Form 3160-5  
(June 2015)UNITED STATES  
DEPARTMENT OF THE INTERIOR  
BUREAU OF LAND MANAGEMENT**SUNDRY NOTICES AND REPORTS ON WELLS****Do not use this form for proposals to drill or to re-enter an abandoned well. Use Form 3160-3 (APD) for such proposals.**FORM APPROVED  
OMB No. 1004-0137  
Expires: January 31, 20185. Lease Serial No. **NMMN100558**

8. Well Name and No. **RDX FEDERAL 28 14**9. API Well No. **30-015-43013**10. Field and Pool or Exploratory Area  
**ROSS DRAW; DELAWARE, WEST**11. Country or Parish, State  
**EDDY COUNTY, NM**

**OK AS PROPOSED****APPROVED****By Keith Immatty at 8:25 am, Jan 14, 2026**14. I hereby certify that the foregoing is true and correct. Name (*Printed/Typed*)

## WELLBORE DIAGRAM - PROPOSED

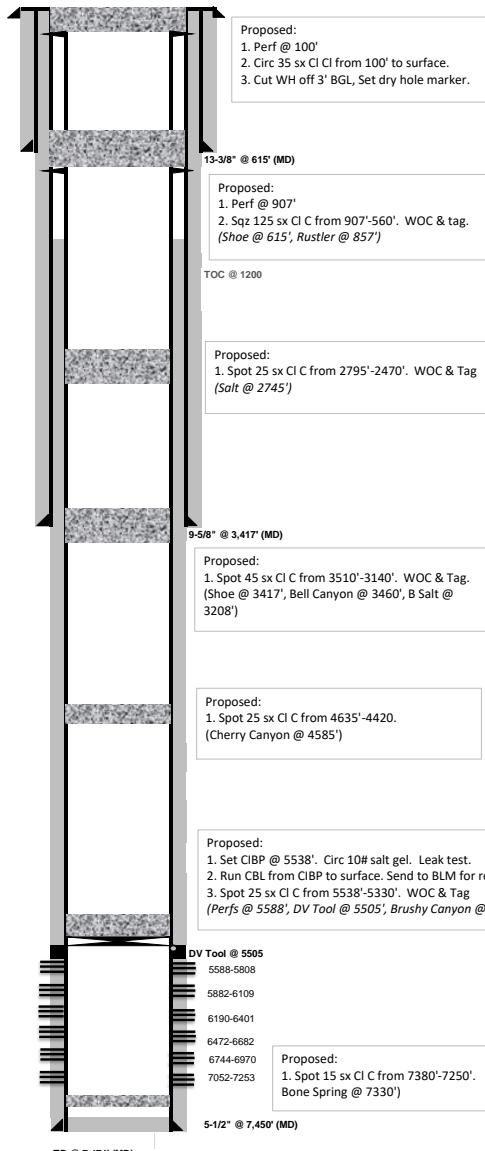
Proposed:											
1. Spot 25 sx CI C from 4635'-4420. (Cherry Canyon @ 4585')

Proposed:											
1. Set CIBP @ 5538'. Circ 10# salt gel. Leak test.											
2. Run CBL from CIBP to surface. Send to BLM for review.											
3. Spot 25 sx CI C from 5538'-5330'. WOC & Tag (Perfs @ 5588', DV Tool @ 5505', Brushy Canyon @ 5645')

Proposed:  
1. Spot 15 sx CI C from 7380'-7250'. Bone Spring @ 7330'
